FPC documents

Takashi Hachiya
Nara Women's University

- I showed FPC design last week and got useful feedback and comments.
 - Document, Wiring

Proposed idea by Artur

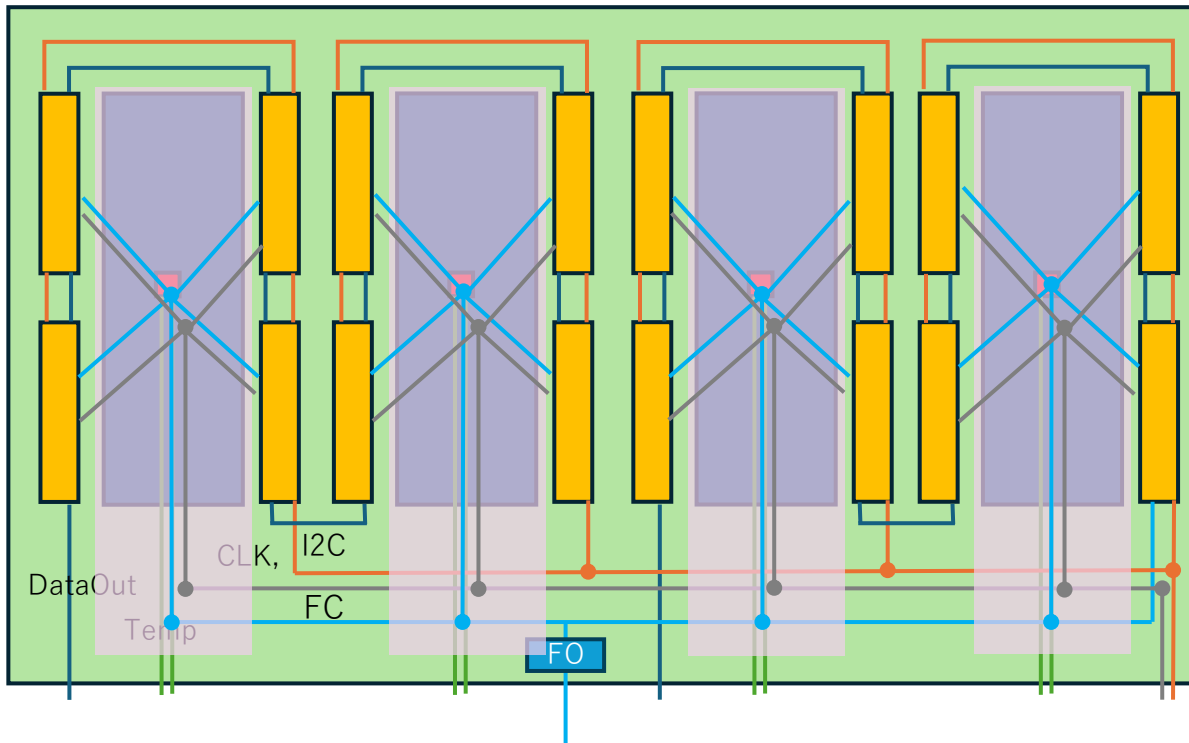
- In the FCFD architecture, we instead prefer:
 - one shared data port among **four** ASICs,
 - and a **multi-drop approach** for the clock input.
- The question regarding whether it is feasible to combine data outputs from 8×32 -channel FCFD ASICs is therefore directly relevant to the intended architecture.
- To reduce clock/fast comm line in FPC
 - One clock input to stavelet and split by FanOut

- Good to discuss and test using the prototype
 - OK to mount extra active device ?

FCFD ROC v1.2

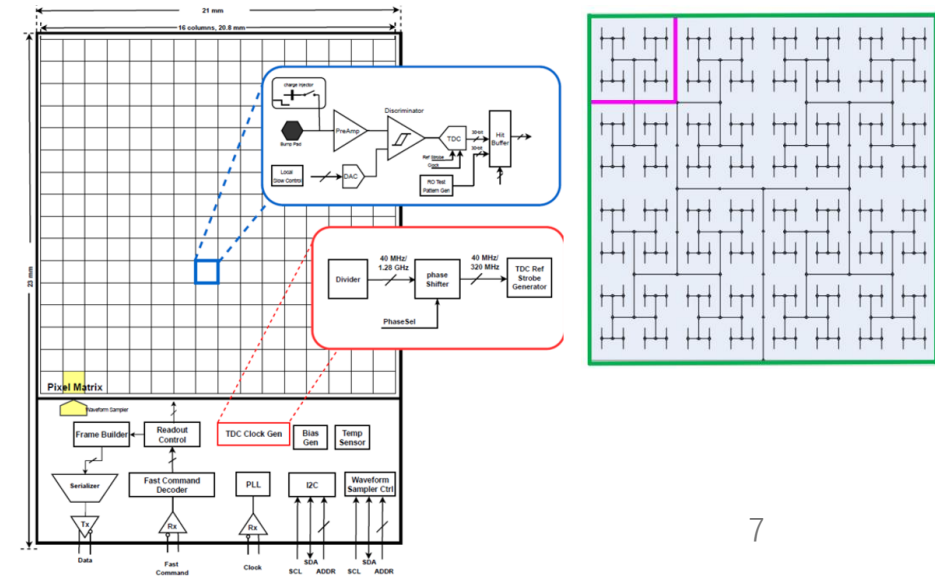
- Pin assignment found and two reset PIN (DIG-RSTN, I2C-RSTN). Two line needed?
- No daisy chain in v1.2 ?
- Not equal length wiring of the clock network

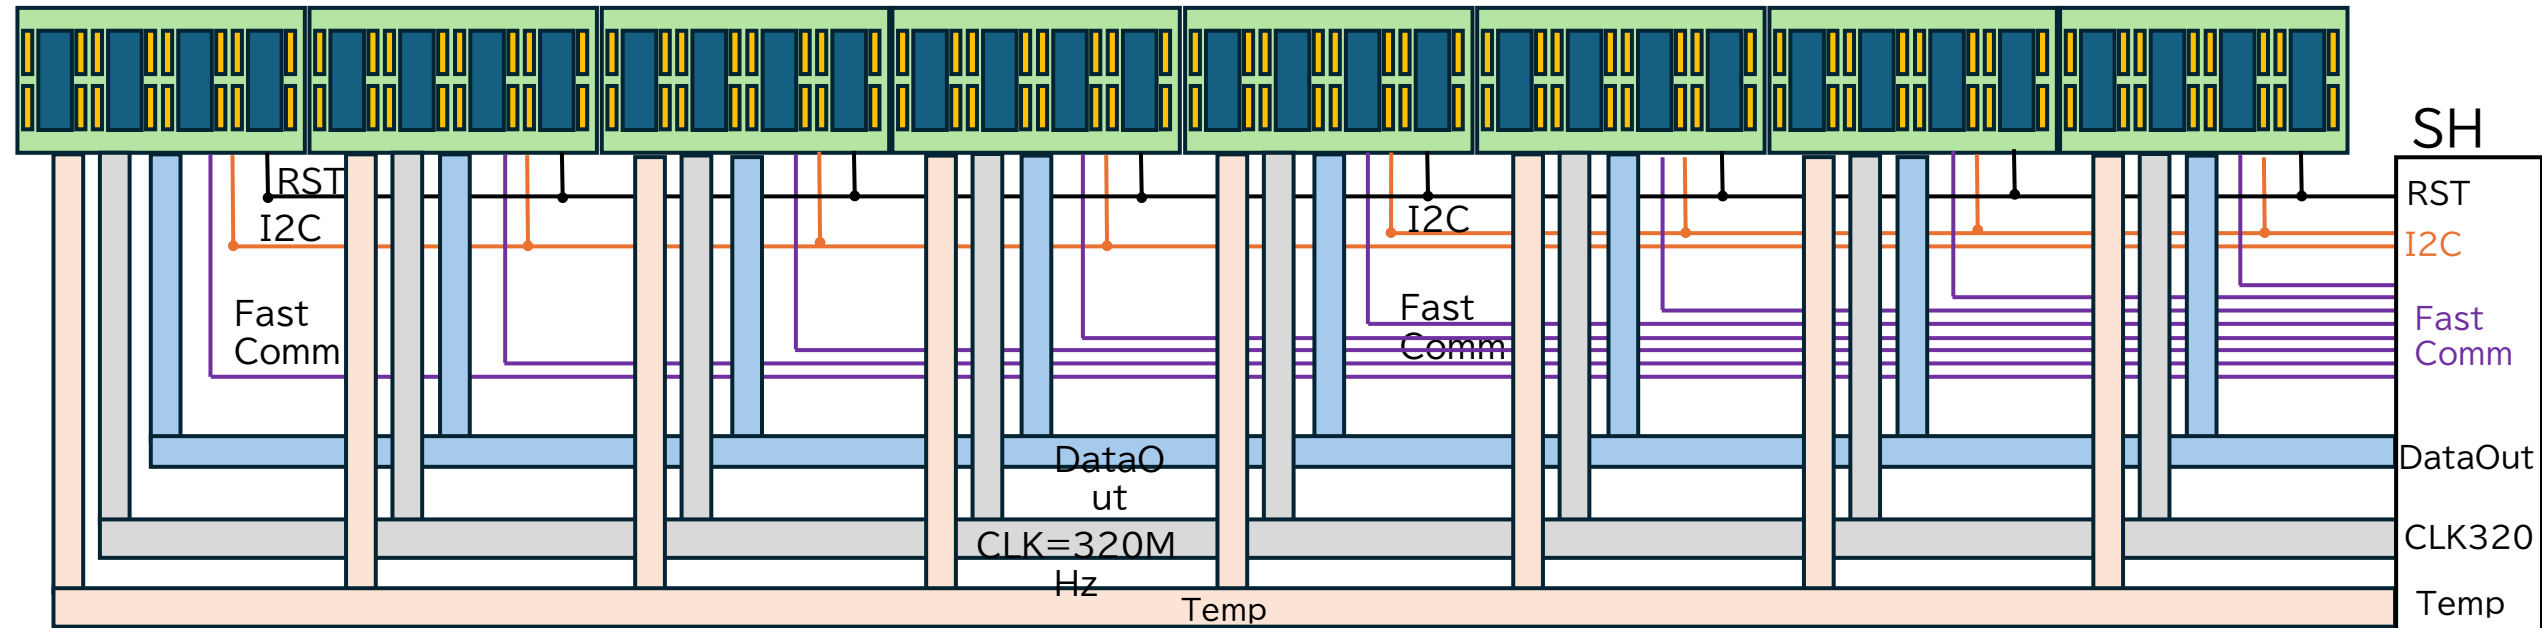
- The current FPC concept appears to assume that each 32-channel FCFD ASIC requires:
 - a dedicated clock input, and a dedicated data output.
- Under this assumption, a single [lpGBT](#) would not provide sufficient connectivity:

- one lpGBT provides 32 clock outputs, but only 28 data inputs.
 - As currently envisioned, the data-port allocation is therefore not feasible.
- In the FCFD architecture, we instead prefer:

- one shared data port among **four** ASICs,
 - and a **multi-drop approach** for the clock input.
 - Both approaches can be evaluated with the FCFD1.2 ASIC

- From our perspective, this **should be feasible**.
- We suggest reducing the number of CLK lines to:
 - one clock line per stavelet/module,
 - followed by a local 1-to-4 fanout stage.

- There is also one fast-command signal shared across the stavelet:
 - this implies that a multi-drop LVDS signal would pass through 16 ASICs.
- Since one lpGBT provides 16 ePort Tx channels, it may be advantageous to:

- use two fast-command lines per stavelet/module,
 - unless the remaining ePort Tx channels are needed elsewhere.
- Even with a single fast-command line, we believe it should still be feasible to:

Same with my thought

each clock for a 128chASIC

New idea

Same with our design

2 fast-comm per stavelet. New idea
